<b>Docket Number:</b>	15-AAER-01
<b>Project Title:</b>	Appliance Efficiency Rulemaking for Toilets, Urinals, Faucets, HVAC Air Filters, Fluorescent Dimming Ballasts, and Heat Pump Water Chilling Packages
<b>TN #:</b>	204199
<b>Document Title:</b>	3M Comments for CEC Air Filter Labeling Proposal (Docket # 15-AAER-1)
<b>Description:</b>	N/A
<b>Filer:</b>	System
<b>Organization:</b>	3M
<b>Submitter Role:</b>	Public
<b>Submission Date:</b>	4/15/2015 5:44:21 AM
<b>Docketed Date:</b>	4/15/2015

**3M Comments for CEC Air Filter Labeling Proposal (Docket # 15-AAER-1)**

**3M Comments for California Energy Commission's Air Filter Labeling Proposal**  
Docket # 15-AAER-1, Appliance Efficiency Pre-Rulemaking

Figure 1. Clean Filter Pressure Drop of 13 Common Air Filter Models

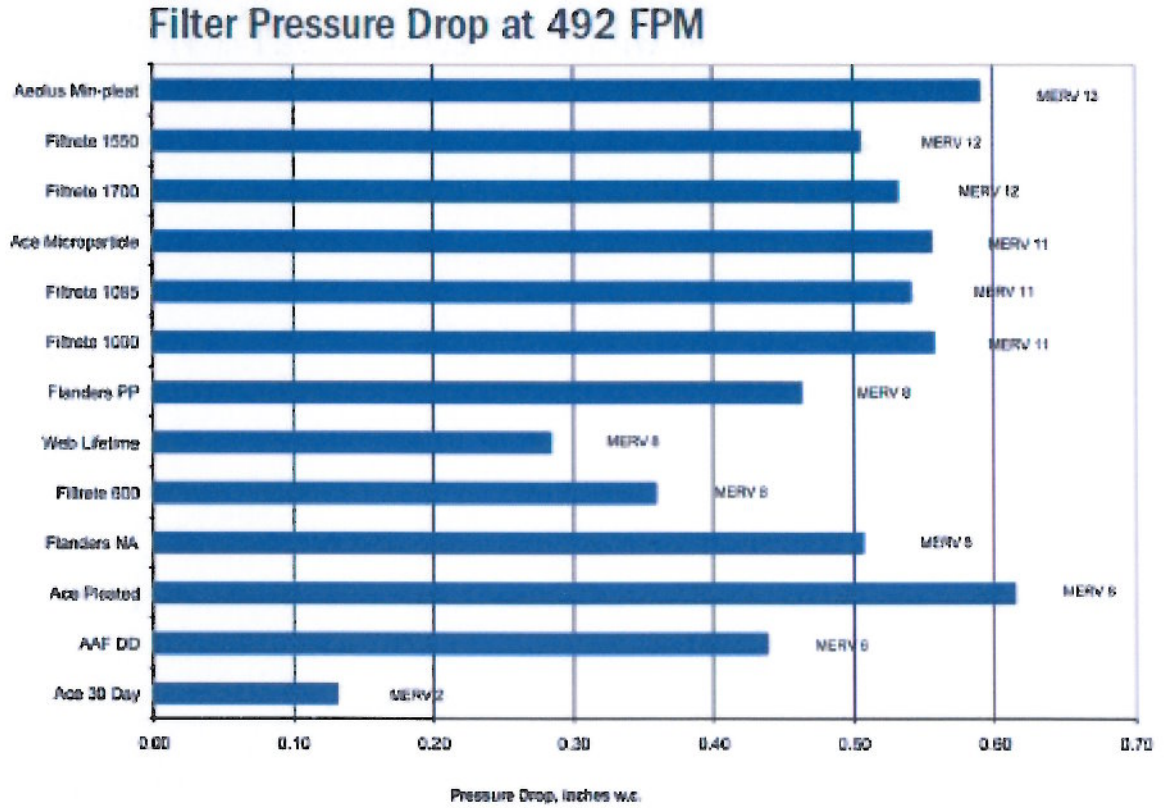
As shown by data in "Staff Analysis of HVAC Air Filters, Dimming Fluorescent Ballasts, and Heat Pump Water Chilling Packages" (see Figure 1), none of current MERV 6 or higher filters achieved 0.1 IWC (inches of water column) at 500 FPM, which is ACCA's rule of thumb recommendation for maximum allowable pressure drop. Even at a much lower air velocity, 295 FPM, none of the MERV 6 or higher filters meets the 0.1 IWC or lower recommendation (see Figure 2), according to 3M

internal testing of a wide range of common air filter models. Therefore, the maximum allowable pressure drop should be a reasonable value. **0.25 IWC at 295FPM is a reasonable value that most of MERV 6 or higher filters can meet.**
